STATE OF CONNECTICUT
CONNECTICUT SITING COUNCIL

Docket No. 272

**ANSWERS OF ABB, INC. TO
FIRST SET OF INTERROGATORIES OF
THE CONNECTICUT LIGHT AND POWER COMPANY AND
THE UNITED ILLUMINATING COMPANY DIRECTED TO ABB, INC.
DATED NOVEMBER 4, 2004**

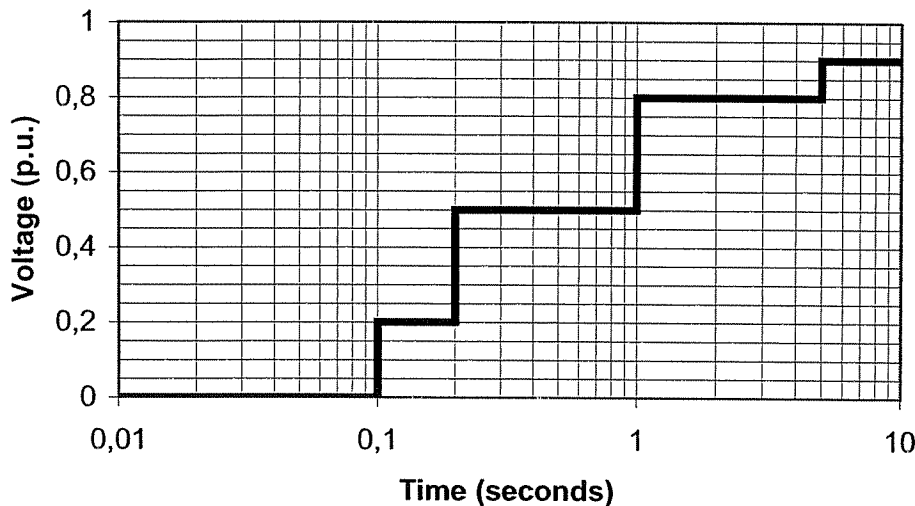
- 6) Please provide a curve of voltage versus time that shows the ability of VSC-HVDC converters to “ride through” low voltage events.

The converter will resume full operation after a low-voltage event greater than the limits in the figure below. The duration of the event can be at least as long as shown in the figure. A longer under voltage time can be supplied if required.

Figure 1. Friction between duct and cable.

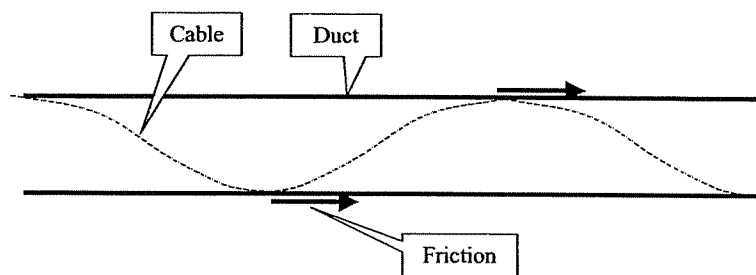
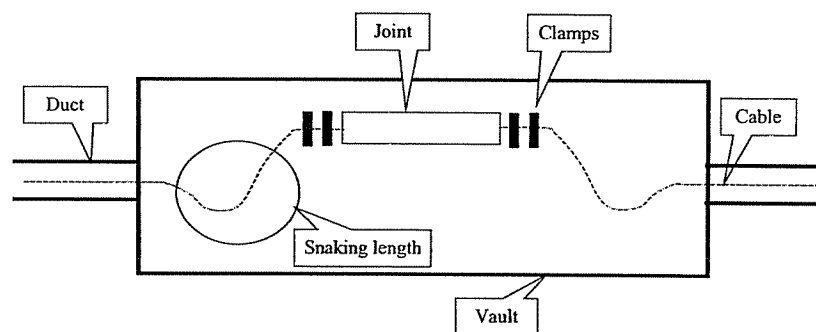
- (a) the cables to be used with the 530 MW converters where the cables are to be installed in duct banks?
- (b) the splices to be used with the cables proposed to be used with the 530 MW converters where the splices are installed in vaults below the surface?
- (c) the integrated cable system proposed to be used with the 530 MW converters in a duct bank?

No. ABB has not performed type and pre-qualification tests on the cables to be used with the 530 MW converters where the cables are to be installed in duct banks.

This fact has to be put into perspective, however. Firstly it has to be noticed that the important aspect of duct installation is the thermo mechanical forces that occur during loading of the cable. These forces are independent of the type of voltage (AC or DC) as well as they are independent of the voltage level (kV). The diameter, weight and maximum temperature of the cable are the most important factors ruling these forces. In other words, installation of VSC-HVDC cables in ducts is not more unique than installation of XLPE AC cables in ducts.

During normal operation the conductor of the cable expands longitudinally if it is not restricted. In buried cable installations this induced movement is restricted by the surrounding soil. In a duct installation the cable is more or less free to move in the duct, depending on the diameter of the duct and the cable. In this case the longitudinal expansion is partly prohibited by the friction between the cable and the duct (see figure 1). This friction functions as a clamp. The remaining expansion is “transmitted” to the end of the cable, typically to the joint in a vault or to the termination. These remaining forces have to be taken care of. This can, for example, be done in the following way (see figure 2). The remaining expansion length is taken care of by allowing the cable to expand (snaking length) in the vault. And, by using clamps on both sides of the joint the longitudinal forces are blocked so that the joint will not “see” these forces and as a result will not be affected. A similar technique can be used for the termination.

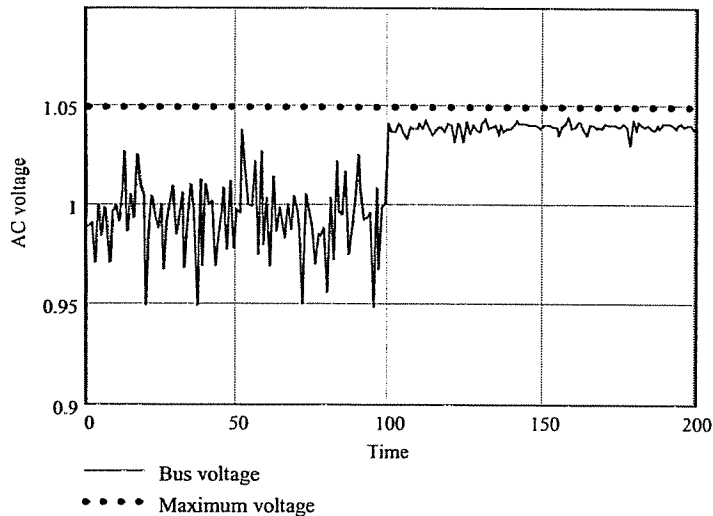
- 14) Please provide the ampacity calculation performed for the proposed cable size and duct bank configurations.

See attached calculation reports for the 3x370 MW and 2x530 MW configurations.

(<Rating calculations 3x370 MW.pdf> and <Rating calculations 2x530 MW.pdf>).

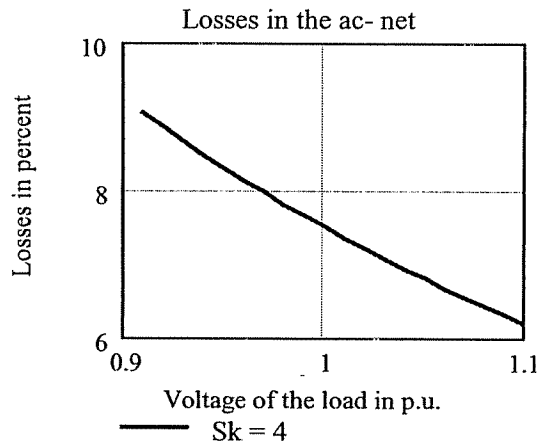
- 15) Please provide the overall system losses, broken down separately by converter station losses and line losses, as a percentage of rated power for each of the three options proposed in the ABB October Report, at 0%, 10%, 50%, and 100% of load.

One part is the reduction of losses in the existing AC grid due to use of the VSC-HVDC converters to control the AC voltage. The inherent reactive power compensation capability of the converters can be used to achieve

- Stabilization of the voltage at a higher level, which decreases the active current in the AC lines (see figure below)
- Reduction of reactive current in the AC lines by balancing the load

These current reductions will decrease the losses in the AC grid. The exact amount can not be calculated by ABB at this time, but should be considered when evaluating the overall system losses. A typical relation between losses in the grid versus voltage is shown in the figure below.
